Re: Plunkett Kuhr SFD – Plan Review Comments (First Review)
WC³ Project #: 217-525-188

We have reviewed the structural plan review comments listed above and dated October 26, 2017. See below for responses in bold italic font to your comments. The numbering of the responses corresponds to the numbering of the review comments.

Upper Floor (Location 2) and Roof Key Plan (Location 1)

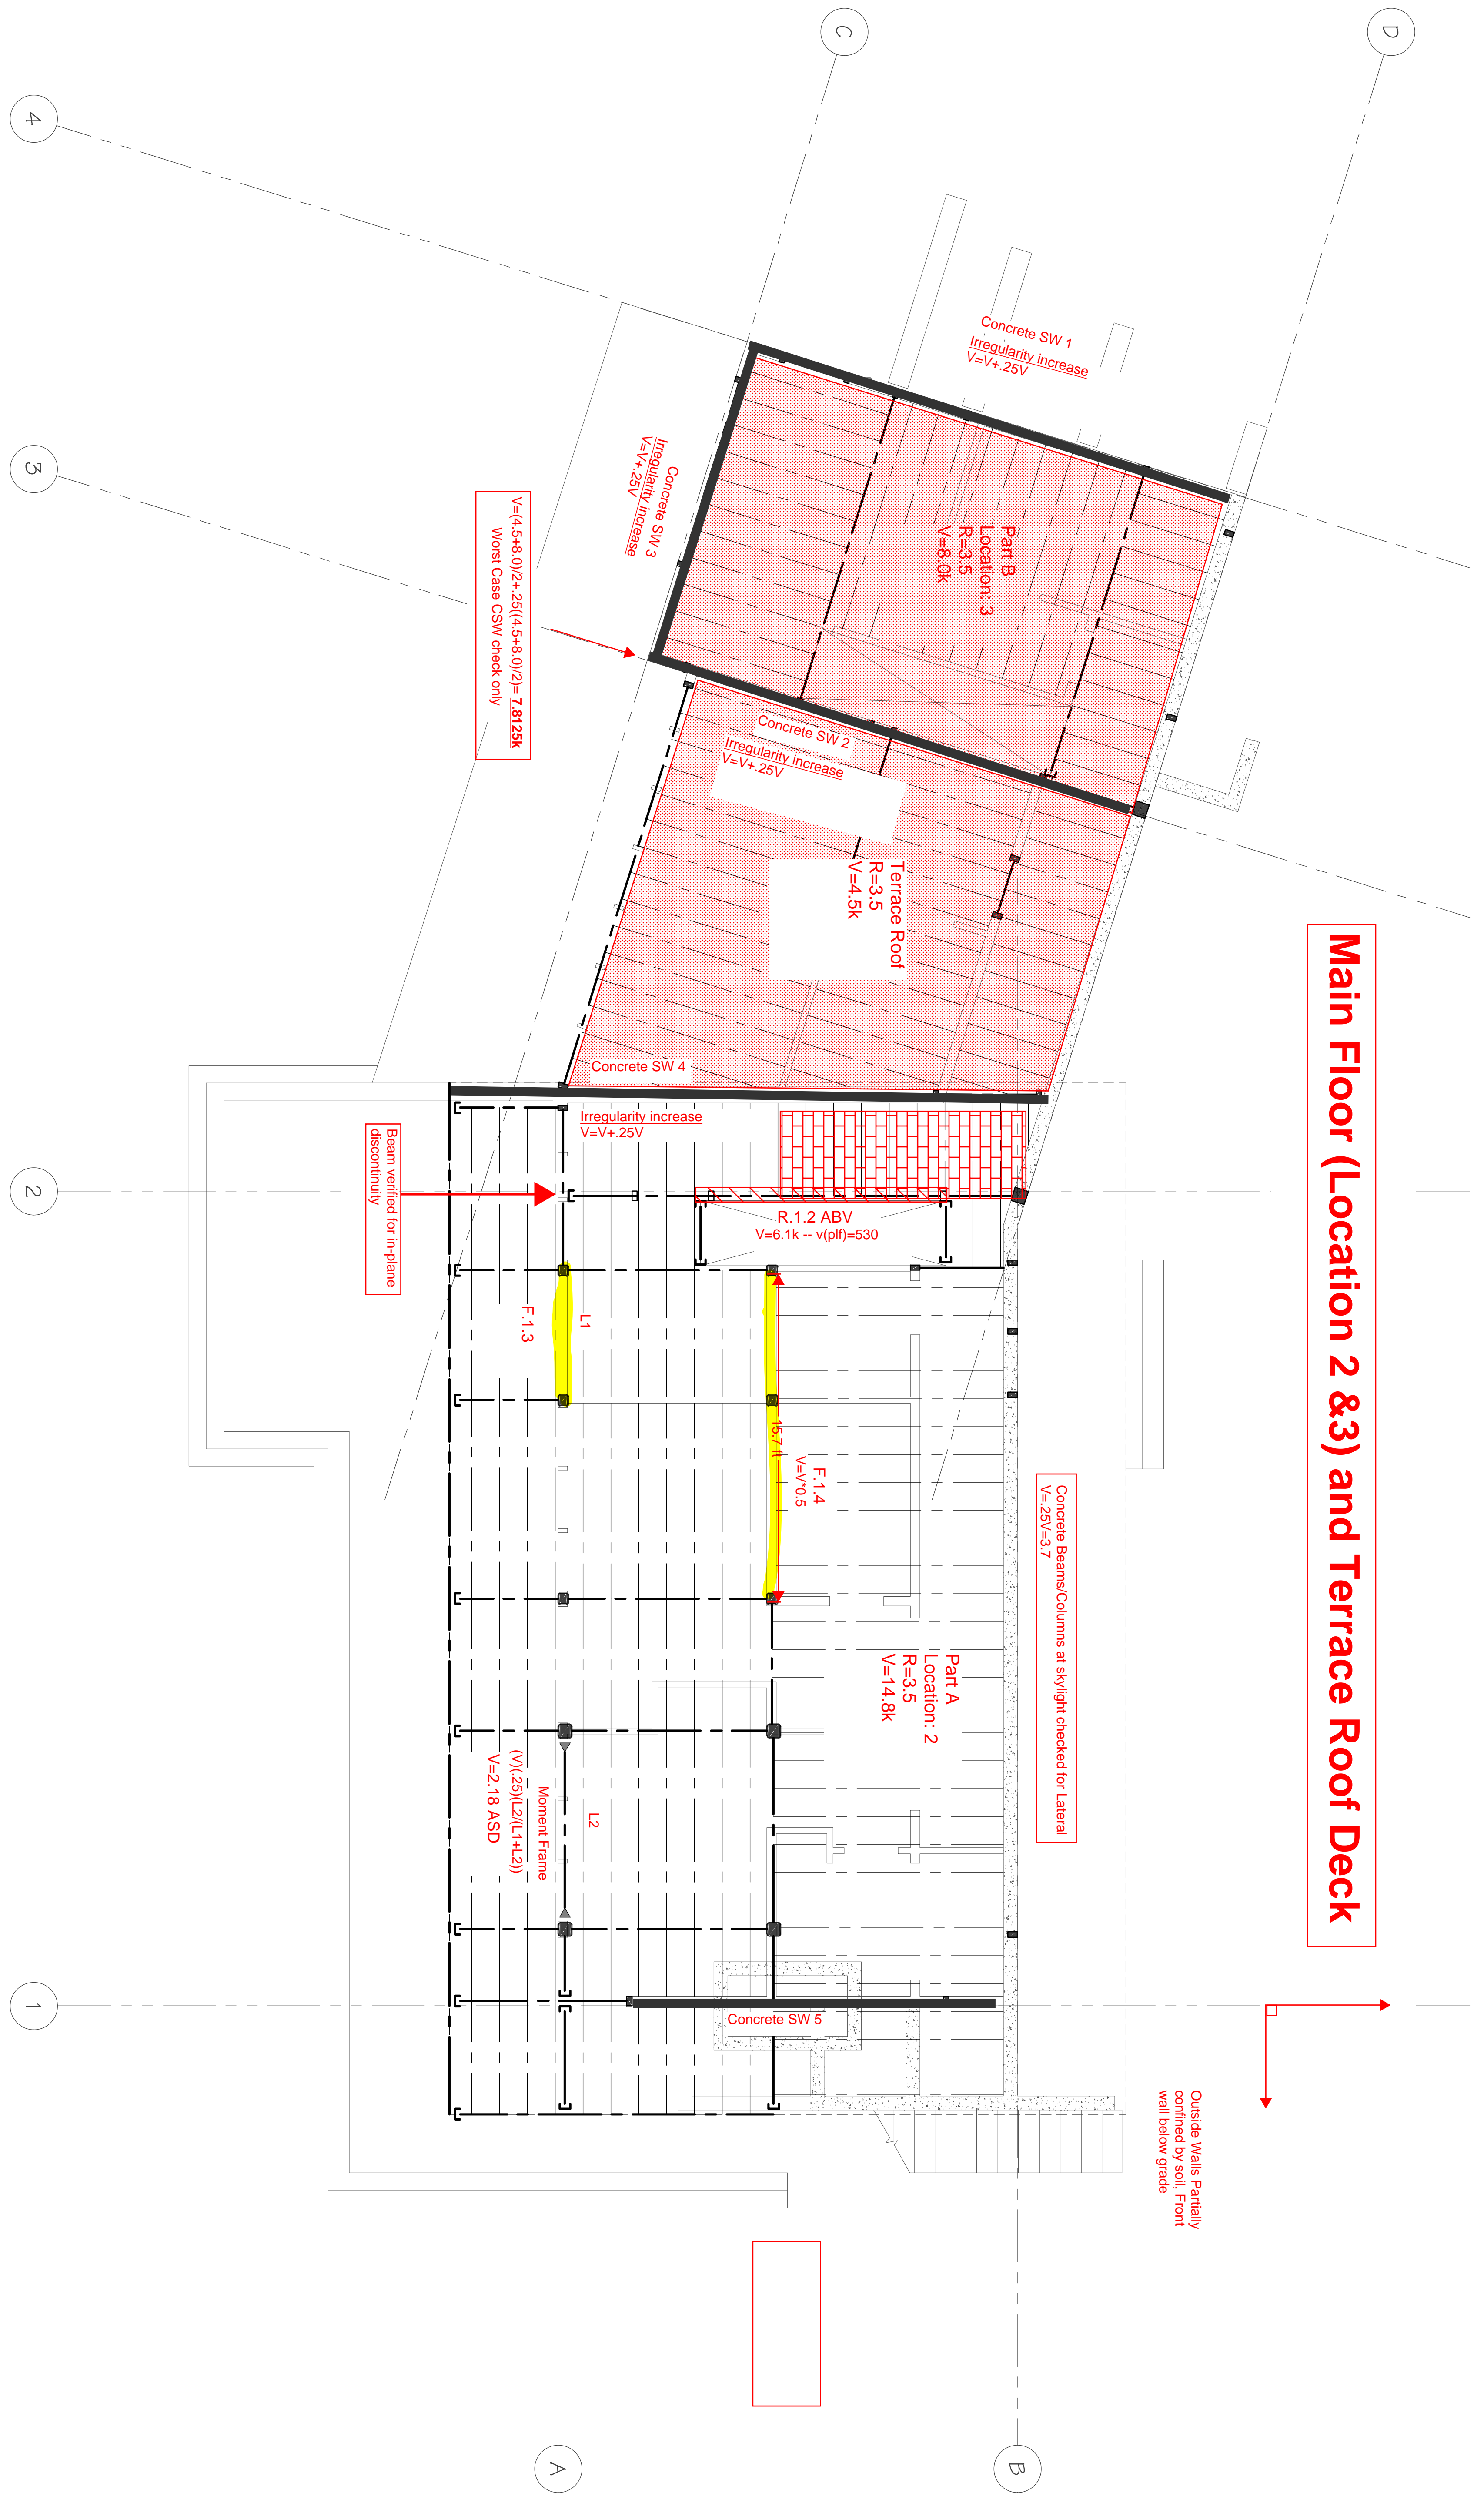
S15. The lateral design was difficult to follow. Please provide a key plan indicating all lateral resisting elements (i.e. shear walls, moment frames, etc.) along with a horizontal distribution of lateral forces per Section 12.8.4 of ASCE 7-10 for the structure showing which walls/frames were considered in the design and the shear load to each wall/frame.

Key plans and horizontal distribution have been added to the supplemental calculations.
